Bury Interchange – Phase 1

Non-Material Amendment Design Document

Design Changes Summary

Platform Plan – Proposed
16012-HBA-BRY-PFM-D-AR-080100

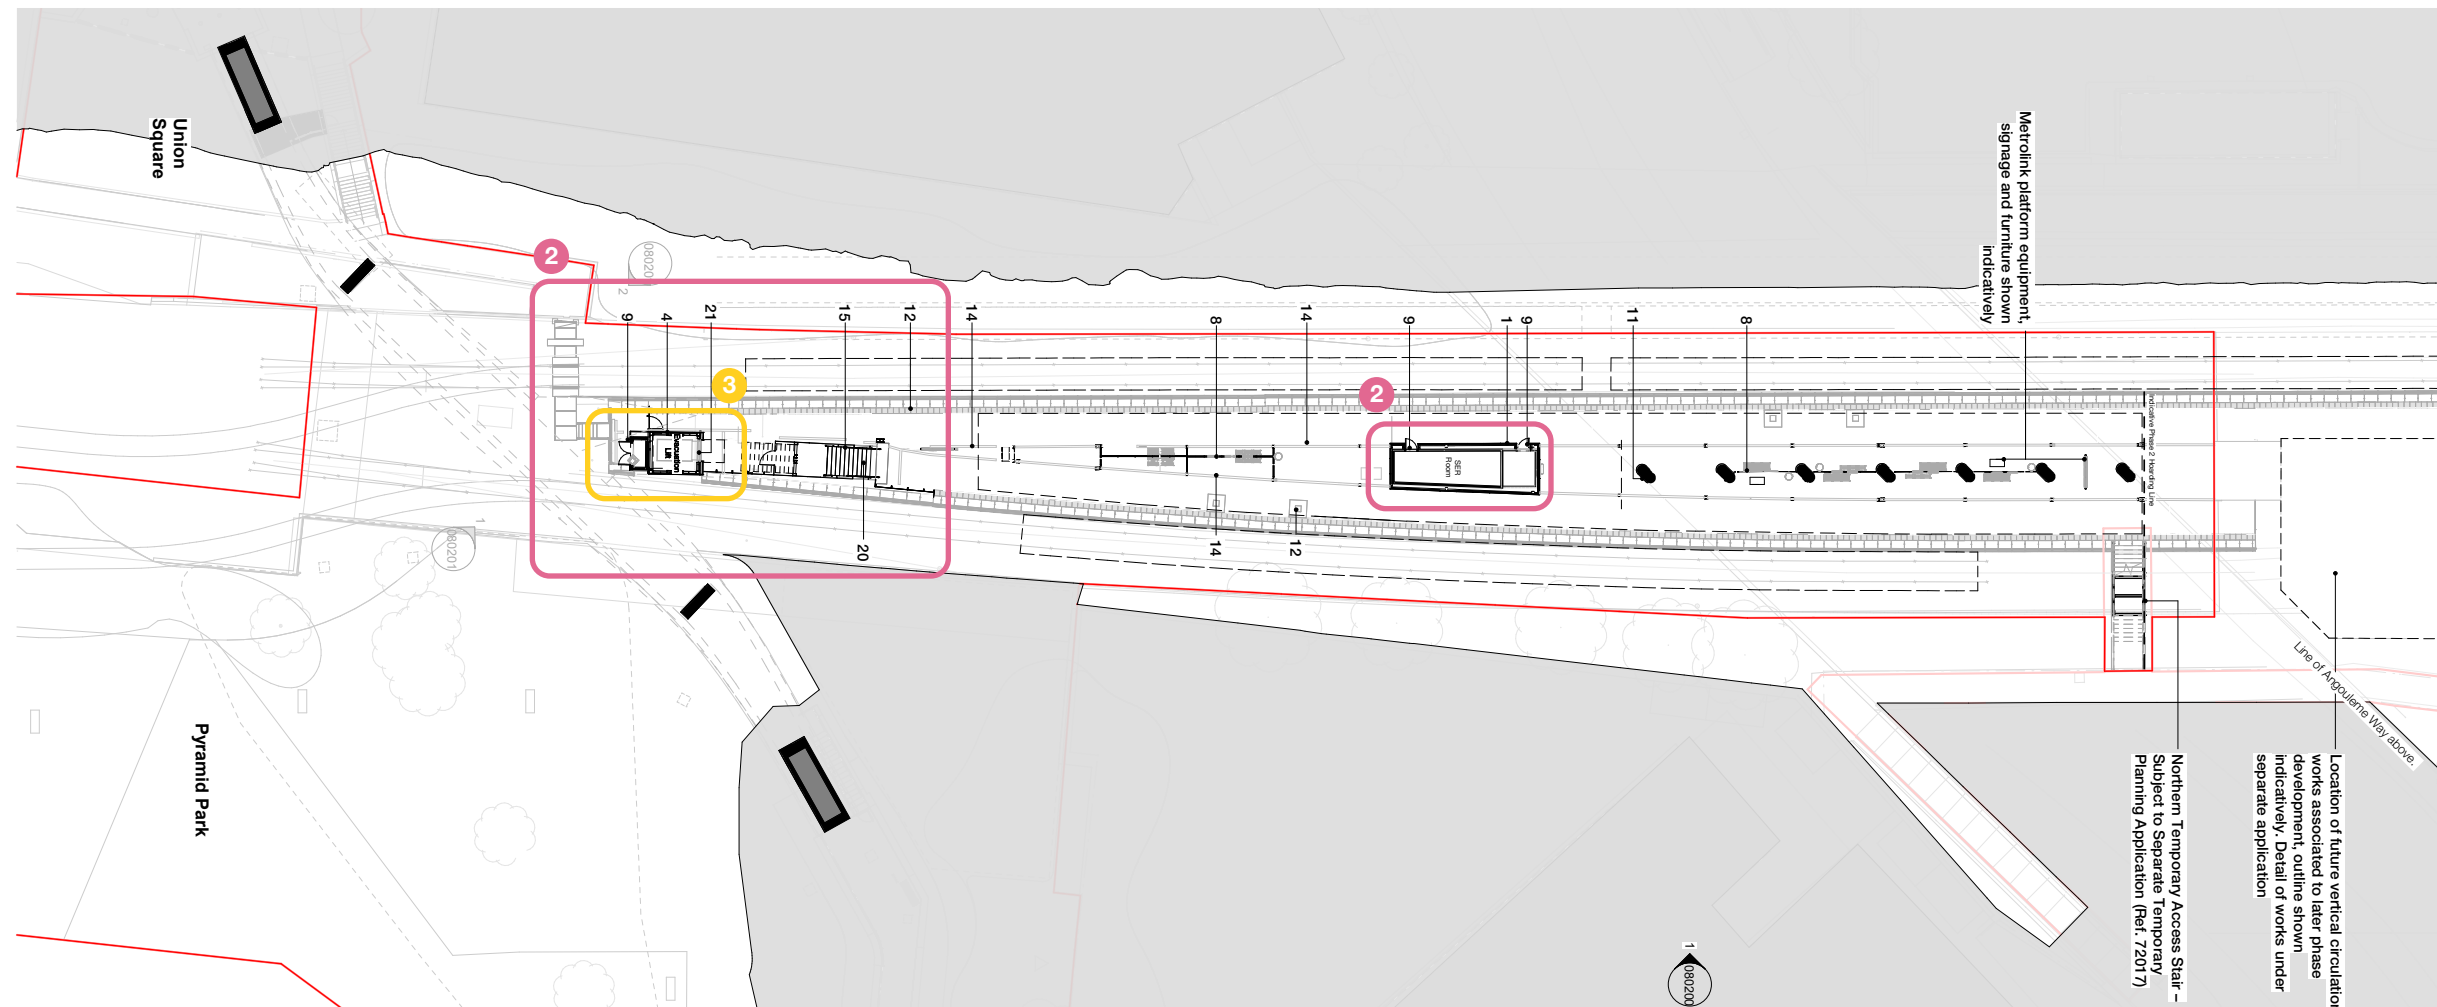
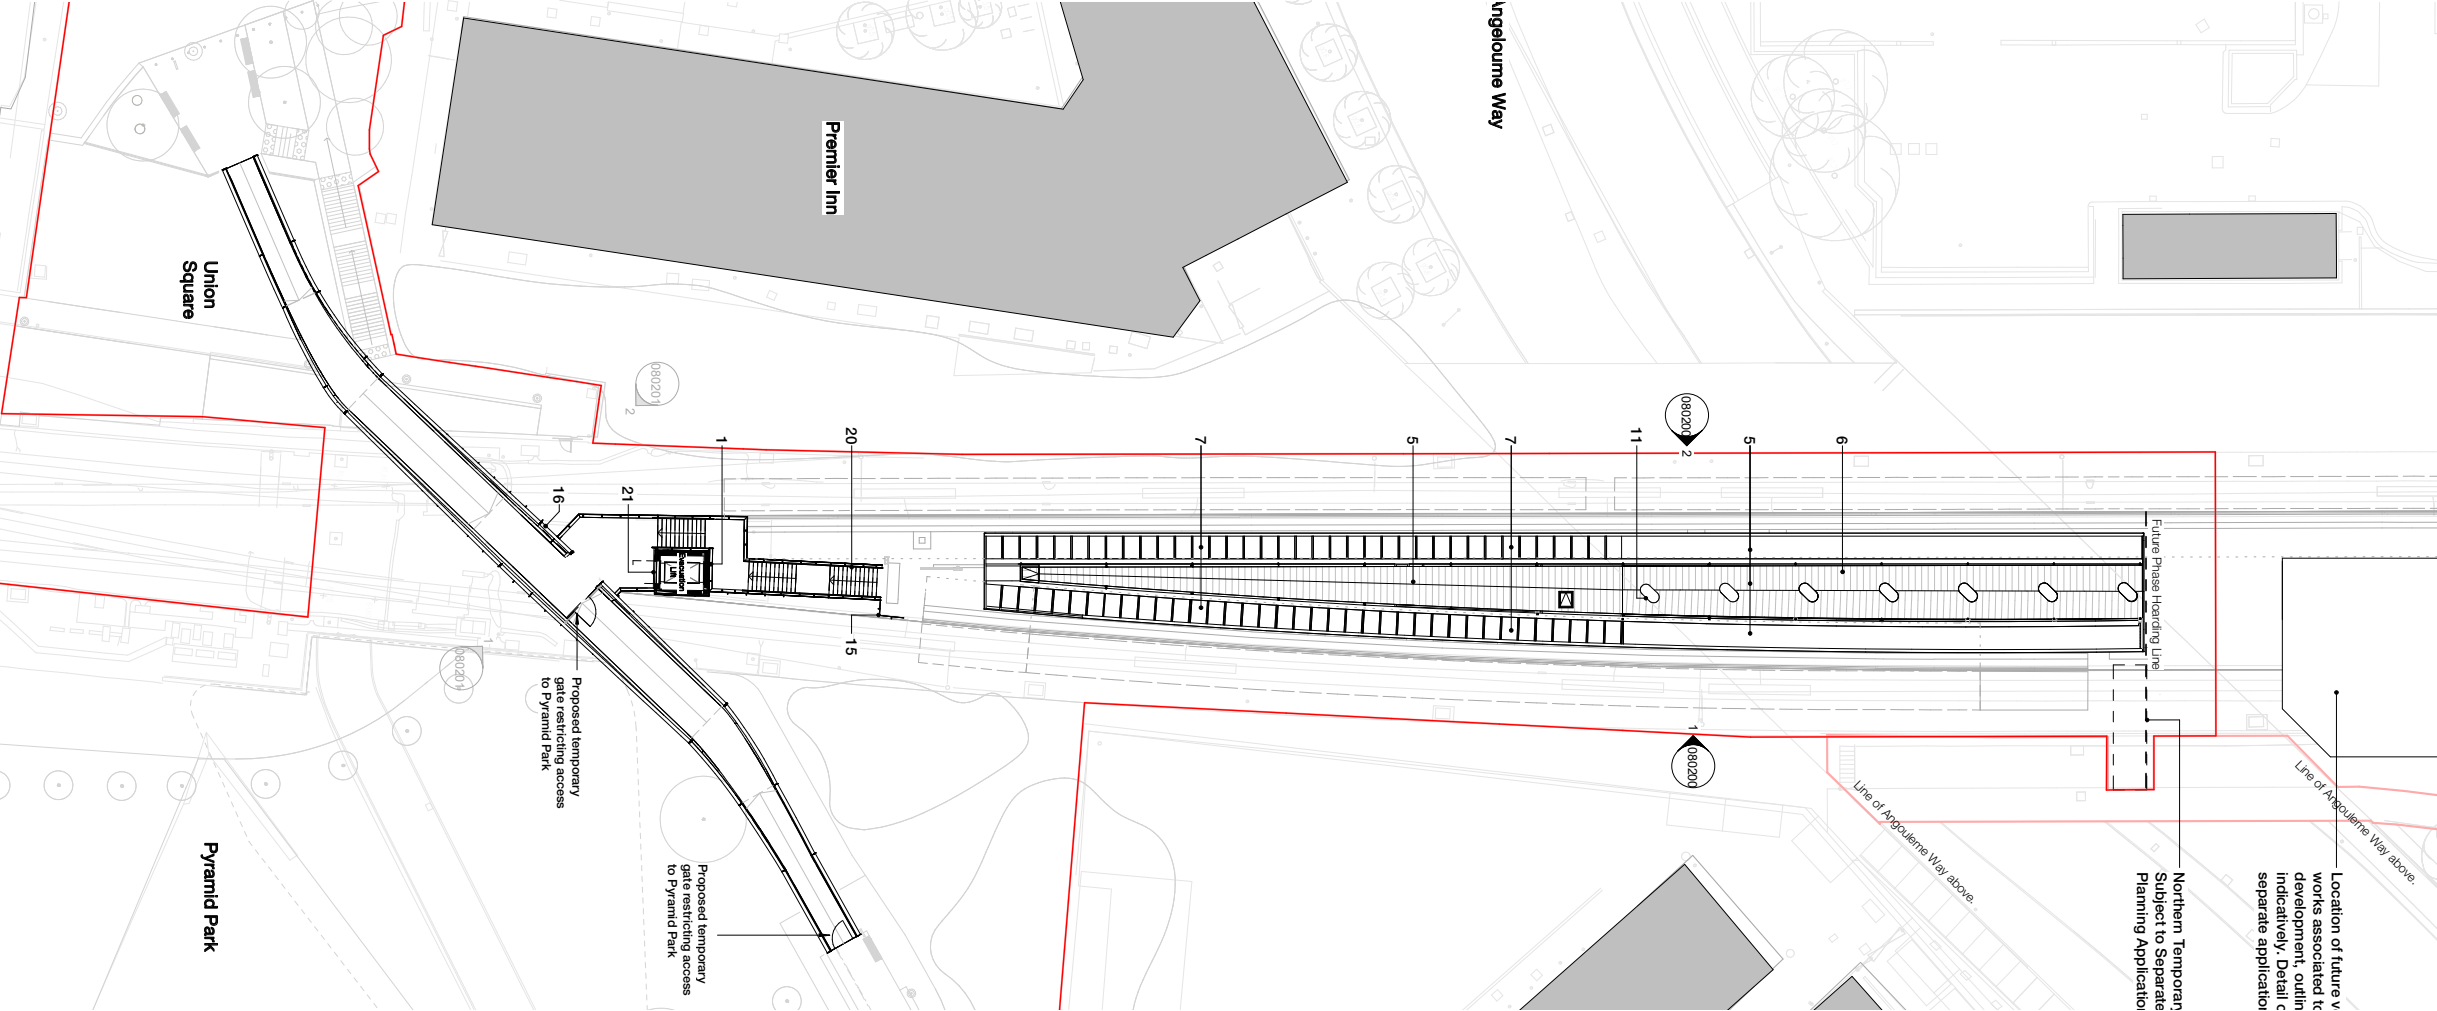
2 Platform Design Development

- Amendments to end of platform arrangement. Ramped track access replaced with gated and stepped access to track
- Minor amendments to door positions and inclusion of louvred door panels to platform SER room
- Minor amendments to platform drainage channel positions and finish
- Guarding to base of southern access stair extended due to platform level changes

Canopy Plan – Proposed
16012-HBA-BRY-CNP-D-AR-080101

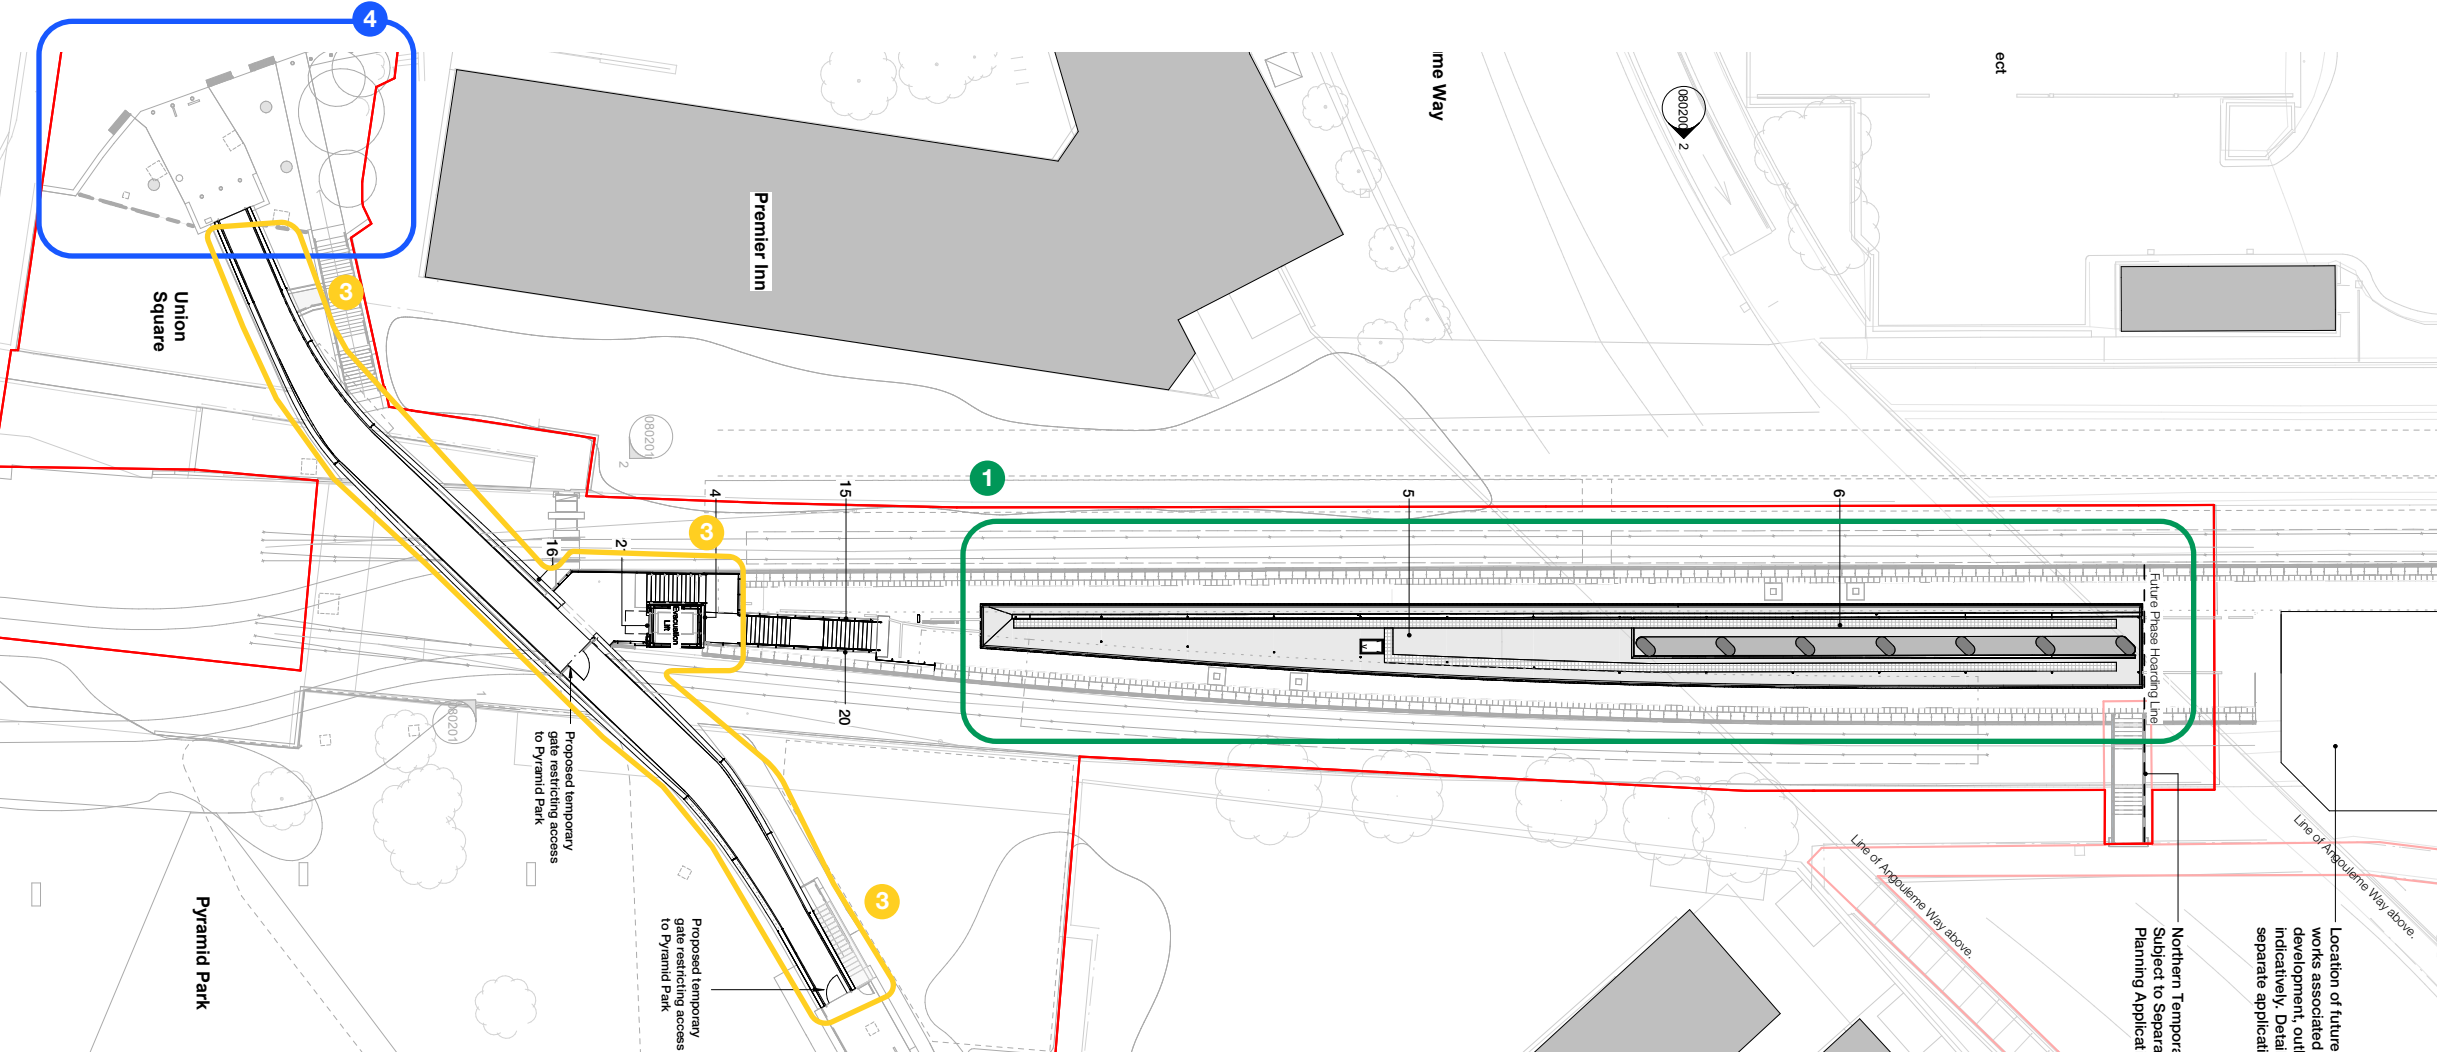
1 Canopy Design Development

- Canopy width, profile, proportions, and height have been further developed to allow the canopy to be located outside of the Metrolink OLE hazard zone.
- Canopy fascia materiality reviewed to strengthen link with the southern access bridge
- Glazing to canopy omitted to simplify maintenance strategy and to align with updated canopy form
- Cladding strategy to existing columns revisited. Cladding omitted to maximise circulation space to the platform

Bridge GA Plan

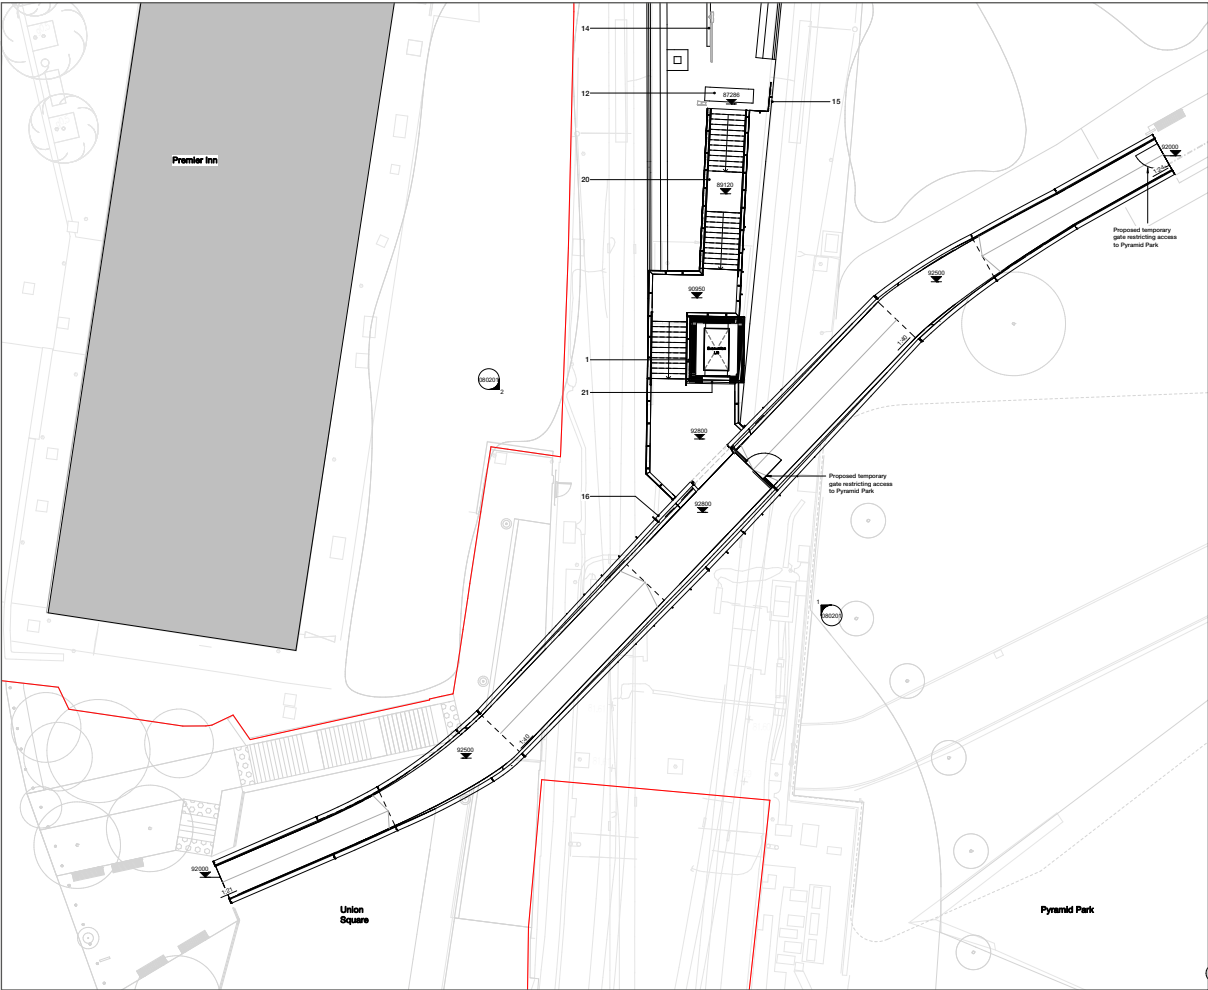
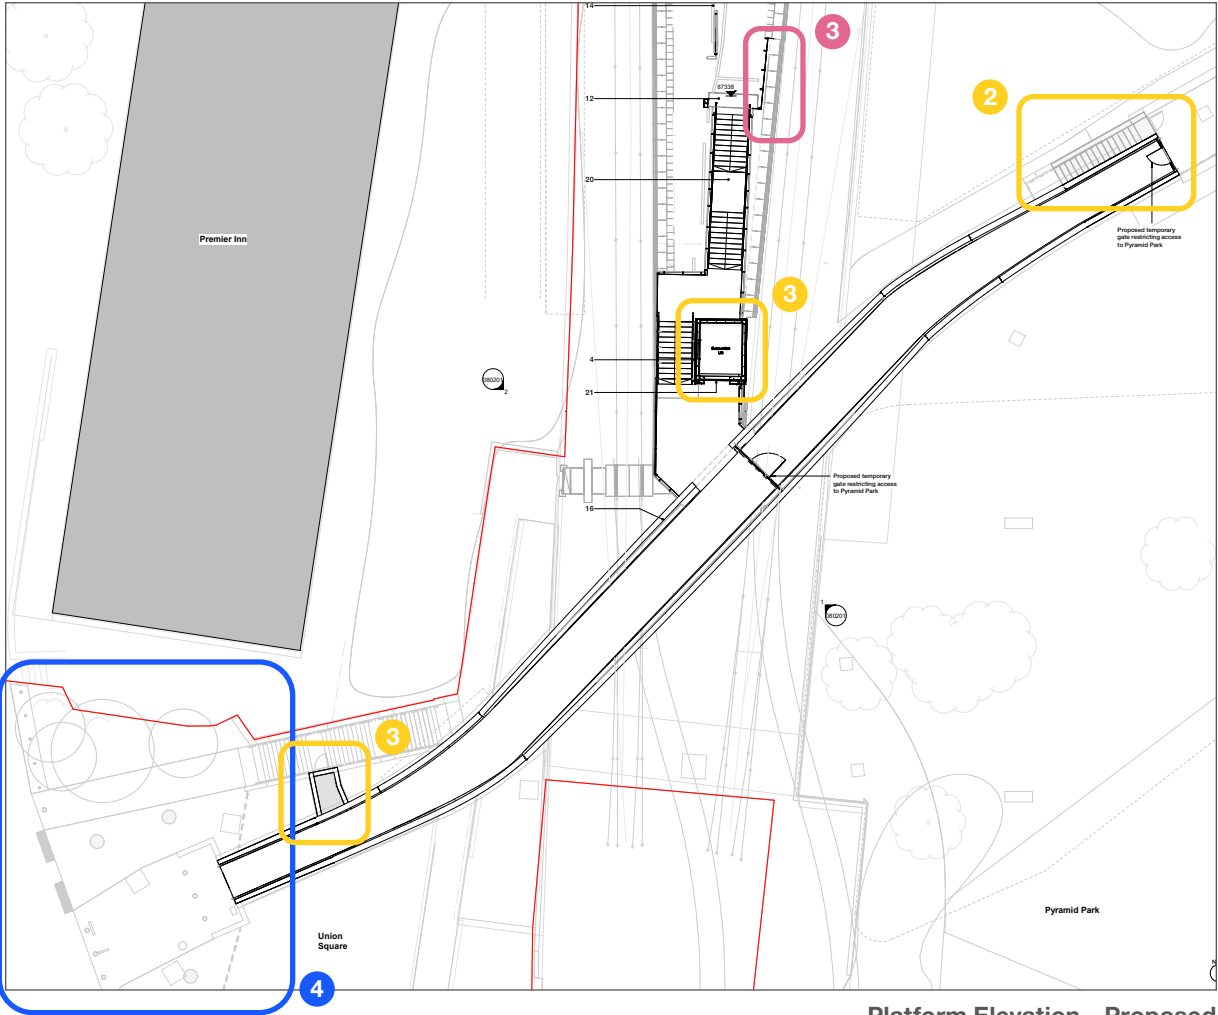
3 Southern Access Design Development

- Amendments to lift shaft door specification. Door changed from glazed to solid in response to technical requirements
- Additional maintenance access stair introduced to provide access to bridge abutments
